Proposed Frontier and Wind Garden Energy Facilities,
Makana Municipality, Eastern Cape

Review of Visual Impact Assessments

20 April 2021

Prepared by
Bernard Oberholzer and Quinton Lawson

map 3 : Fronteer WEF DEFF Screening Tool

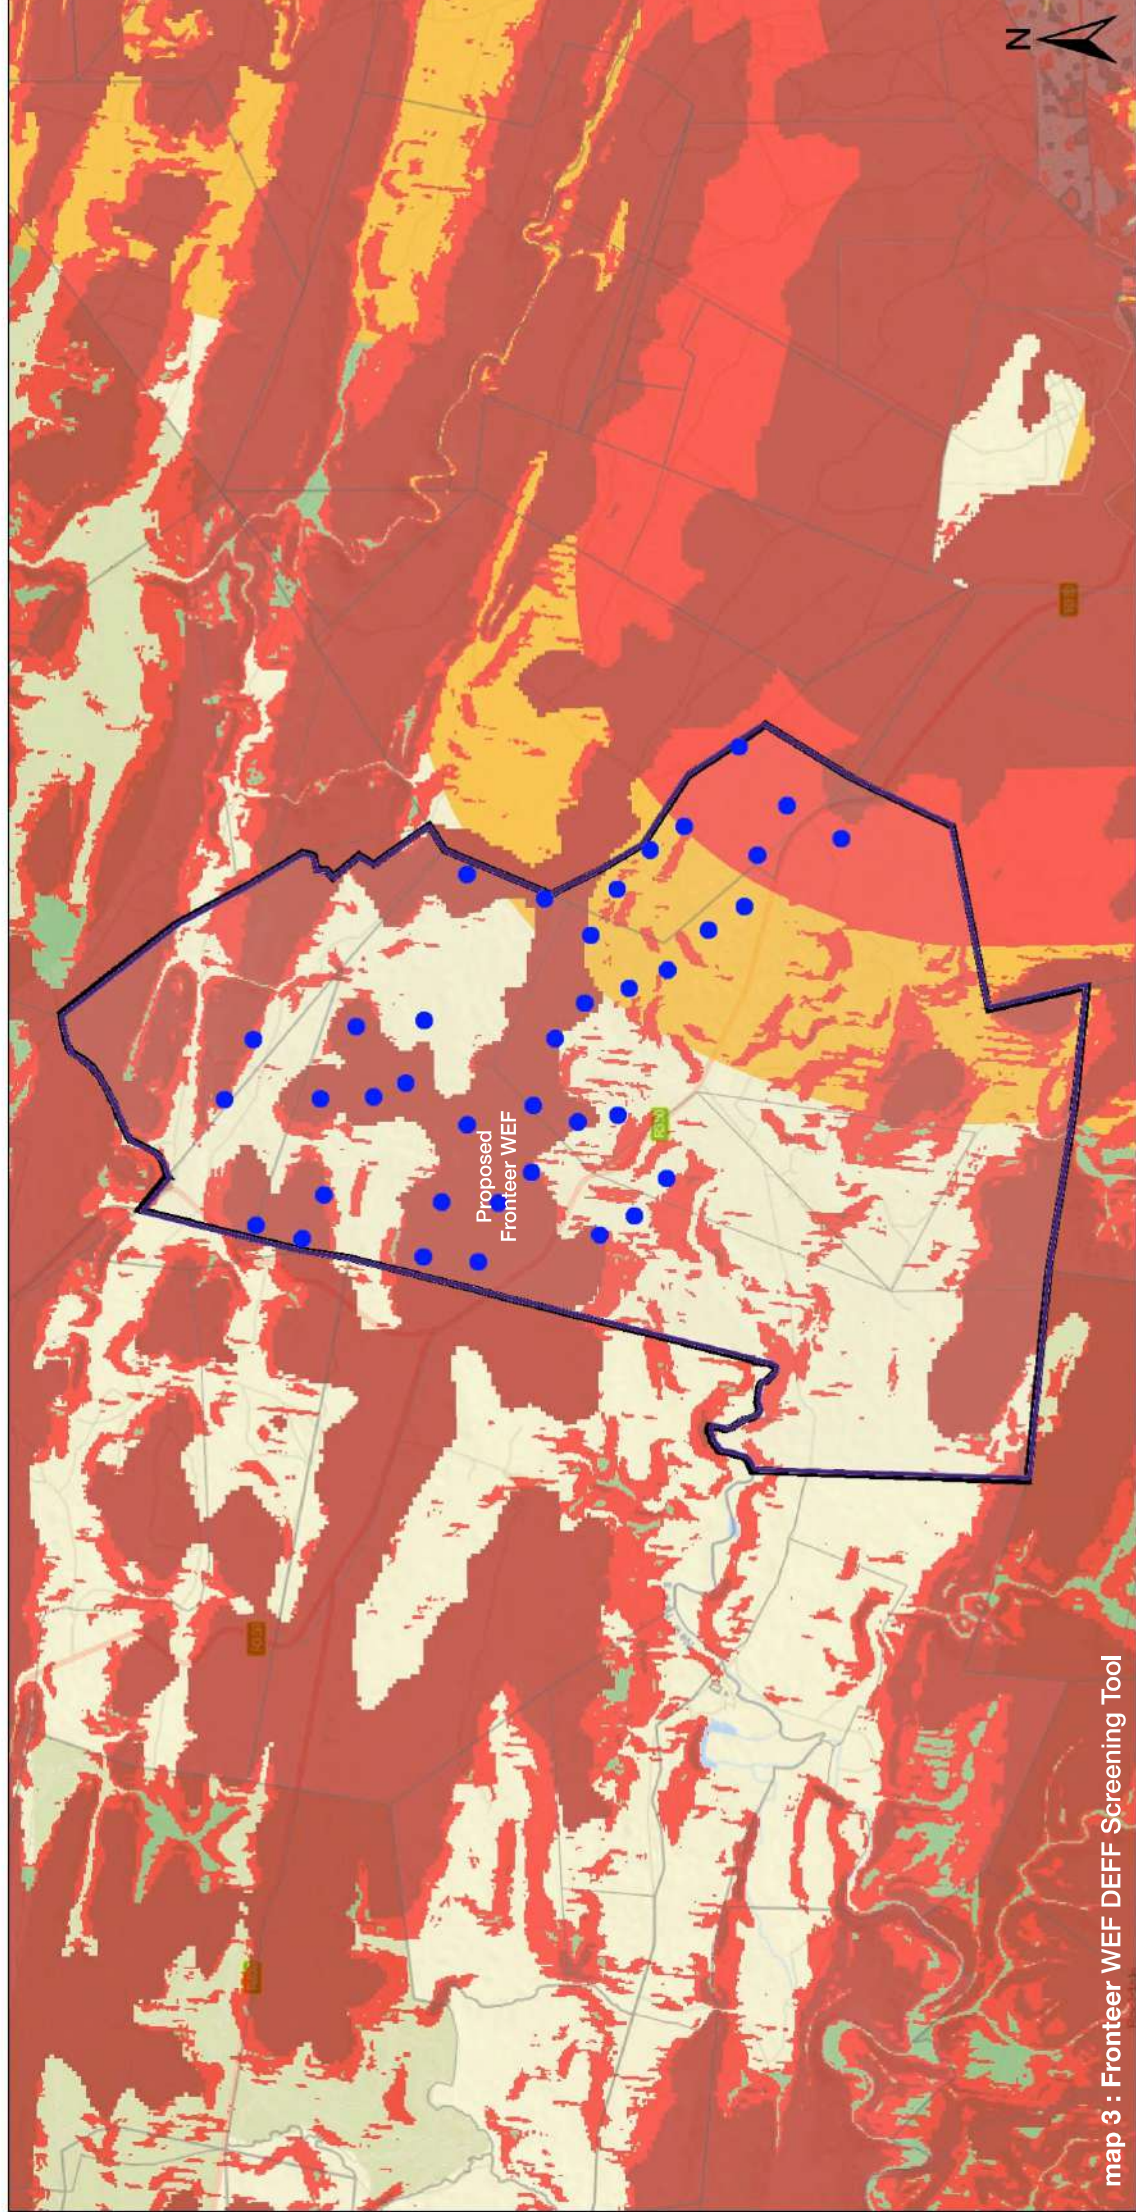
For ease of reference, the Landscape Theme (visual and scenic resources) for the Cookhouse REDZ is attached (Map3) for both the Fronteer and Wind Garden sites. The maps indicate that a number of the proposed wind turbines would occur in a 'very high' sensitivity zone. The VIA Report is then required to confirm or dispute the DEFF screening map.

map 14 : Fronteer WEF • Visual Sensitivity : Airfields 3km, Makhanda Airport 8km

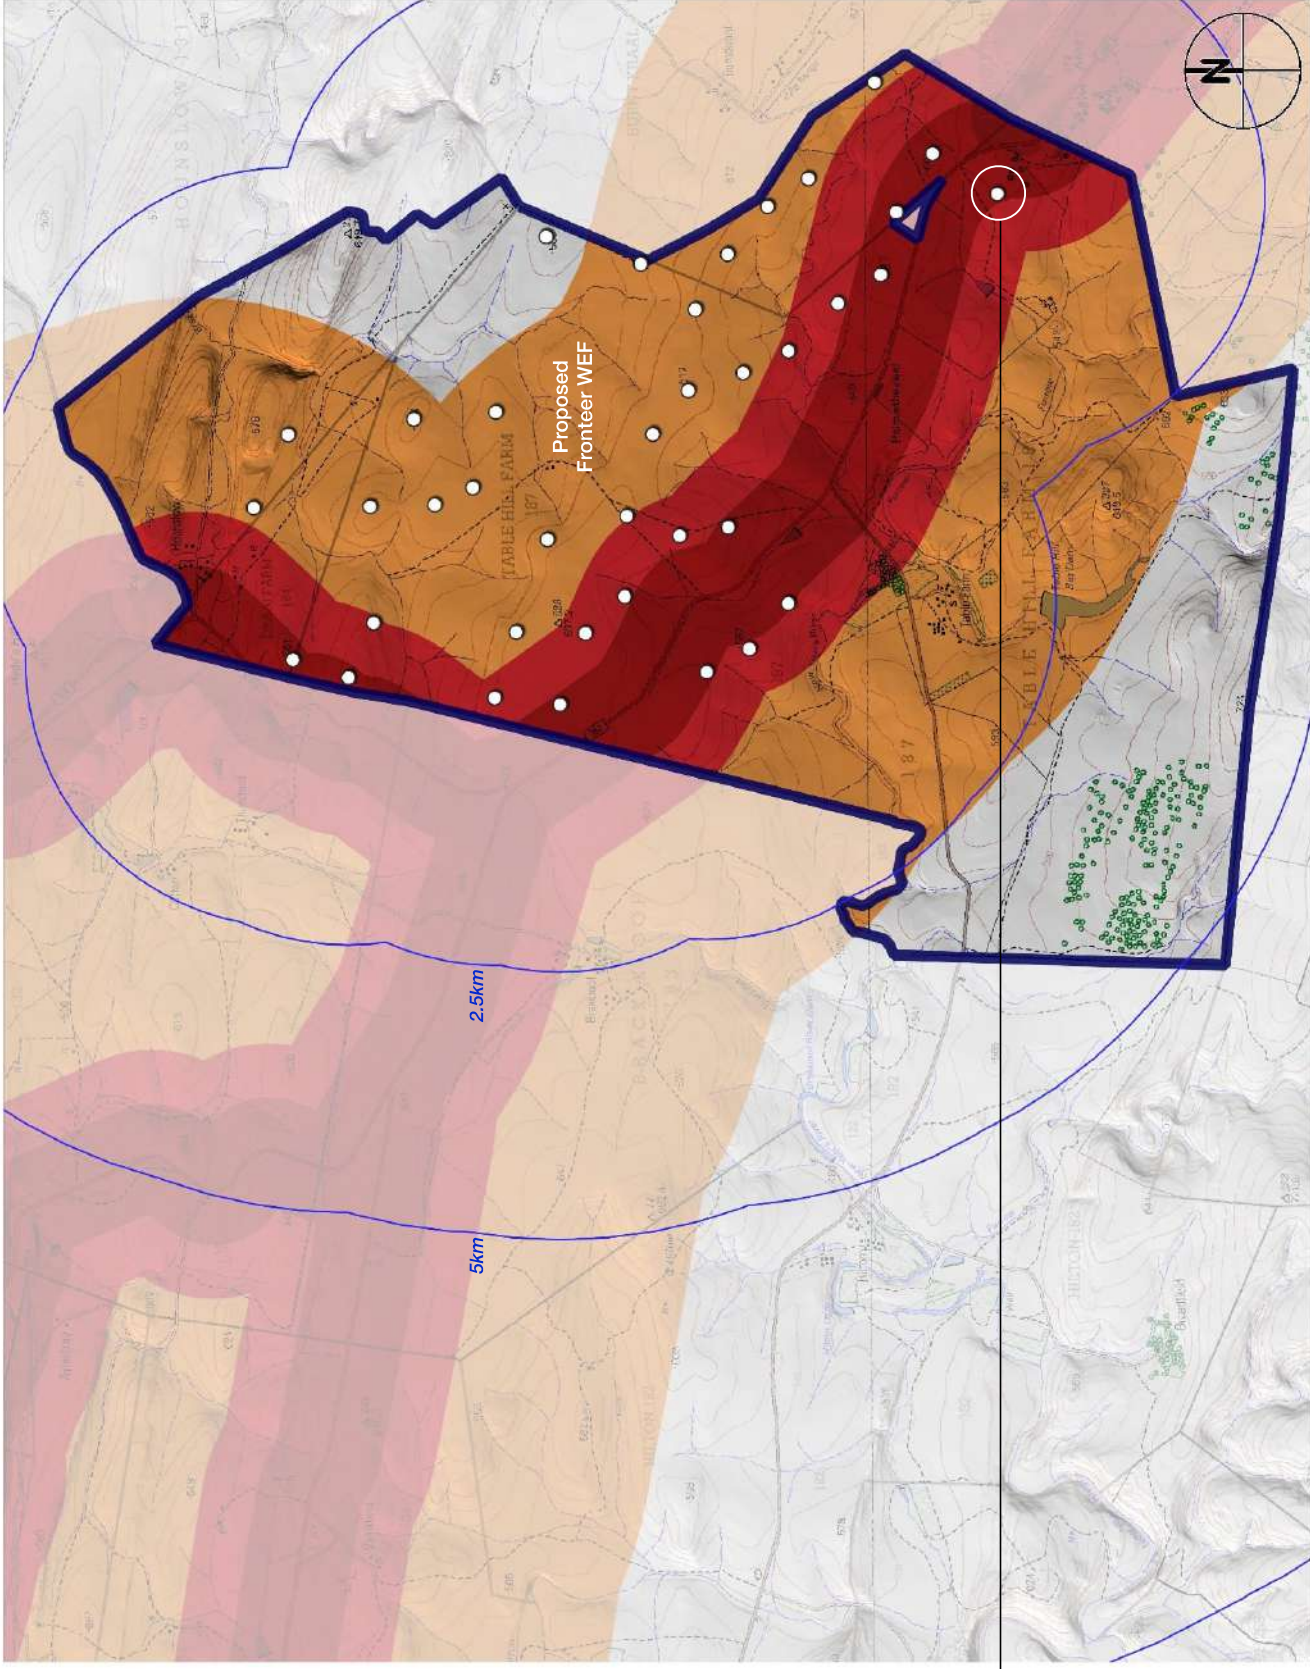
The 8km buffer is indicated on the attached Map 14, indicating that the siting of about half of the wind turbines in the proposed Fronteer Wind Farm could be affected.
